139 FERC ¶ 61,247  
UNITED STATES OF AMERICA  
FEDERAL ENERGY REGULATORY COMMISSION

Docket Nos. RM12-6-000 and RM12-7-000

Revisions to Electric Reliability Organization Definition of Bulk Electric System and  
Rules of Procedure

ACTION: Notice of Proposed Rulemaking.

**Figure 2****Networked Configuration w/115 kV Loop**

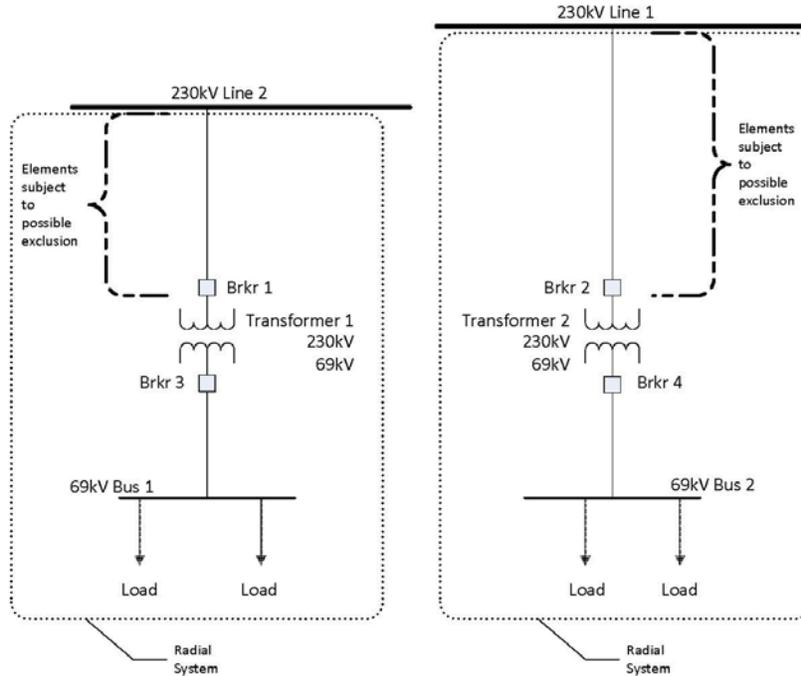
80. Another scenario shown in figure 2 below depicts a configuration containing a 115 kV loop, with the configuration emanating from two points of connection of 100 kV or higher. We seek comment whether, in this configuration, the 115 kV and 230 kV elements above Transformers 1 and 2 to the points of connection to the two 230 kV lines would be excluded from the bulk electric system pursuant to exclusion E1. Is the configuration shown in figure 2 more appropriately analyzed pursuant to the “local network” exclusion E3 and, if so, what if any elements operated at or above 100 kV would be excluded pursuant to exclusion E3?

**Figure 1**

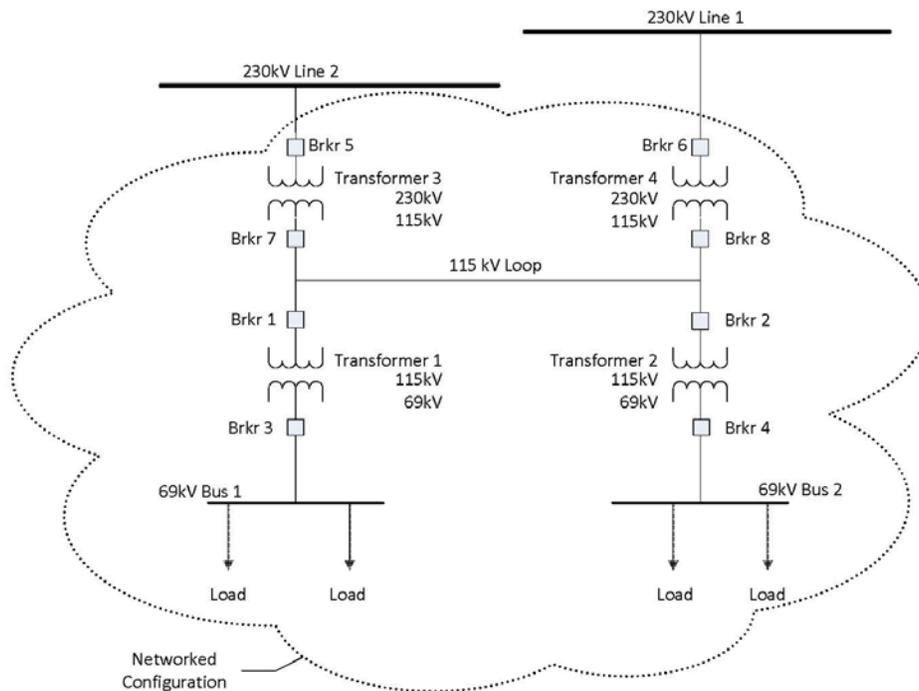
79. Figure 1 below depicts facilities configurations in which all of the 230 kV and 69 kV transmission elements emanate from a single point of connection of 100 kV or higher. The Commission seeks comment on whether each of the radial systems shown in figure 1, the 230 kV elements above each transformer to the point of connection to each 230 kV line, respectively, are excluded from the bulk electric system pursuant to exclusion E1.

**Figure 3**

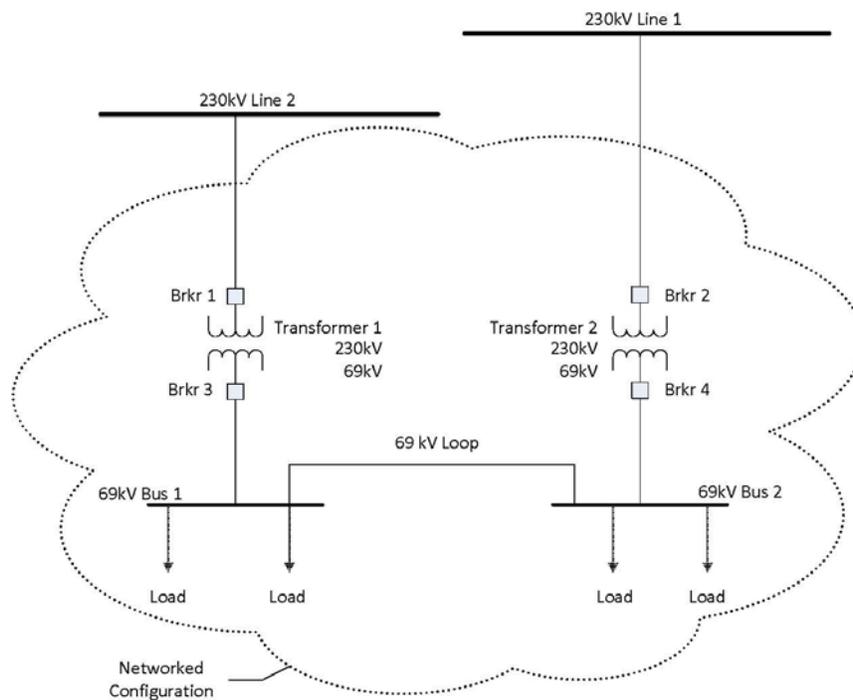
81. The Commission agrees with NERC that ‘radial systems’ only serving load and emanating from a single point of connection of 100 kV or higher should be excluded from the bulk electric system. The Commission is concerned that the exclusion could allow elements operating at 100 kV or higher in a configuration that emanates from two or more points of connection to be deemed “radial” even though the configuration remains contiguous through elements that are operated below 100 kV. For example, figure 3 below depicts a configuration with two points of connection of 100 kV or higher that are contiguous through a 69 kV loop. We seek comment on how to evaluate the configuration in figure 3 vis-à-vis the radial system definition and whether it is appropriate to examine the elements below 100 kV to determine if the configuration

meets the exclusion E1 definition for radial systems. In other words, does figure 3 depict a system emanating from two points of connection at 230 kV and, therefore, the 230 kV elements above the transformers to the points of connection to the two 230 kV lines would not be eligible for the exclusion E1 notwithstanding the connection below 100 kV?

**Figure 4**  
**69 kV Networked Configuration with Normally Open Switch**

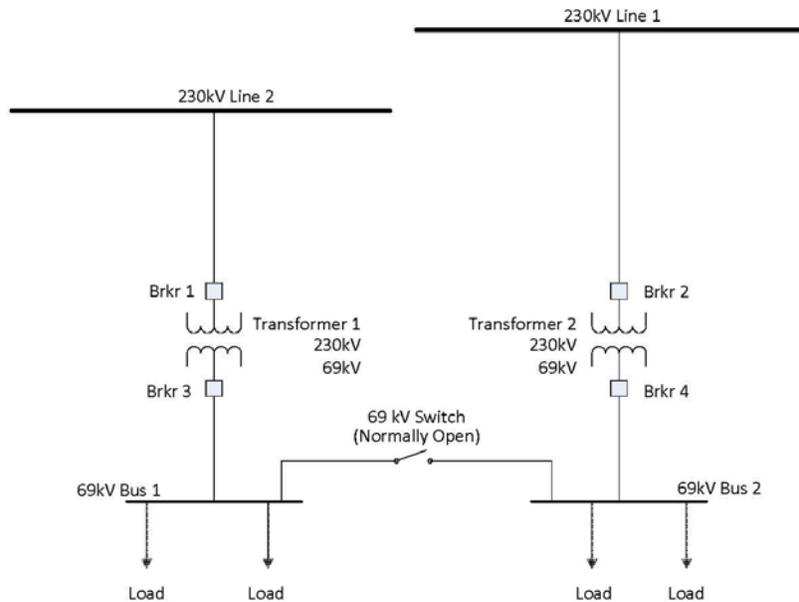
86. Figure 4 below illustrates a configuration with a normally open switch.

switch' in such configuration is well understood in the electric utility industry.”<sup>105</sup> We seek comment on NERC’s characterization and whether the phrase “normally open” is subject to interpretation or misunderstanding, or whether a “normally open” configuration is potentially difficult to oversee. Further, we seek comment on the need of transmission operators or other functional entities to study the system impacts of the closing of a “normally open” switch, or to take other steps to ensure awareness of the impacts of the loop that is created by the closing of the switch if the closed loop is not included as part of the bulk electric system.

**Figure 5**

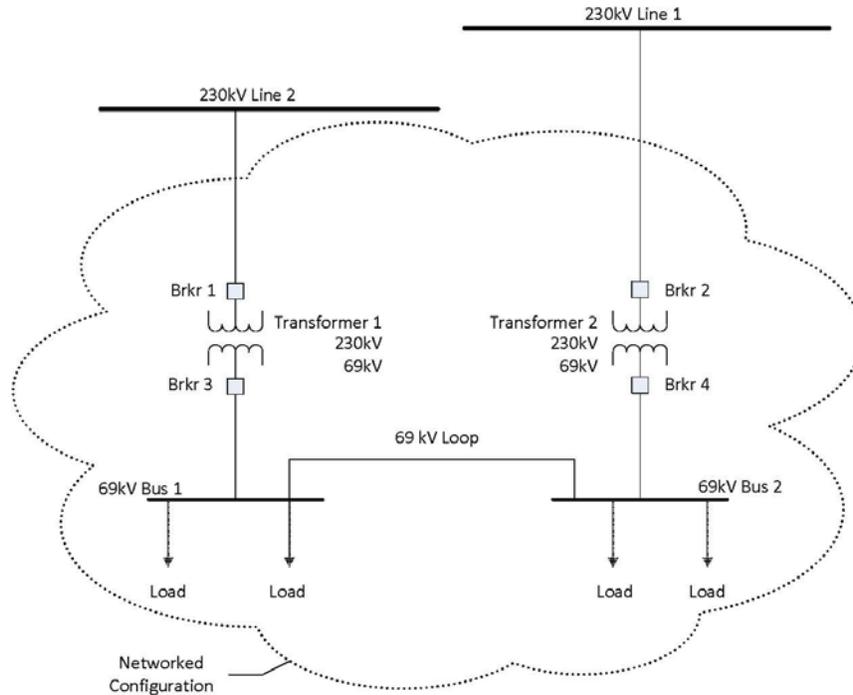
95. As stated above, exclusion E3 defines local networks as “[a] group of *contiguous* transmission Elements *operated at or above 100 kV but less than 300 kV* that distribute power to Load rather than transfer bulk-power across the interconnected system.” While the local network exclusion applies to contiguous transmission elements operating at a minimum of 100 kV, it is unclear how the exclusion applies to a looped lower voltage system. For example, figure 5 depicts a 69 kV looped system emanating from two points of connection at 100 kV or higher.

The configuration in figure 5 depicts a group of elements that are contiguous through a 69 kV loop. We seek comment whether the configuration in figure 5 qualifies as a local network and, in particular, whether the configuration satisfies the condition that a local network consists of “a group of *contiguous* transmission Elements *operated at or above 100 kV....*”
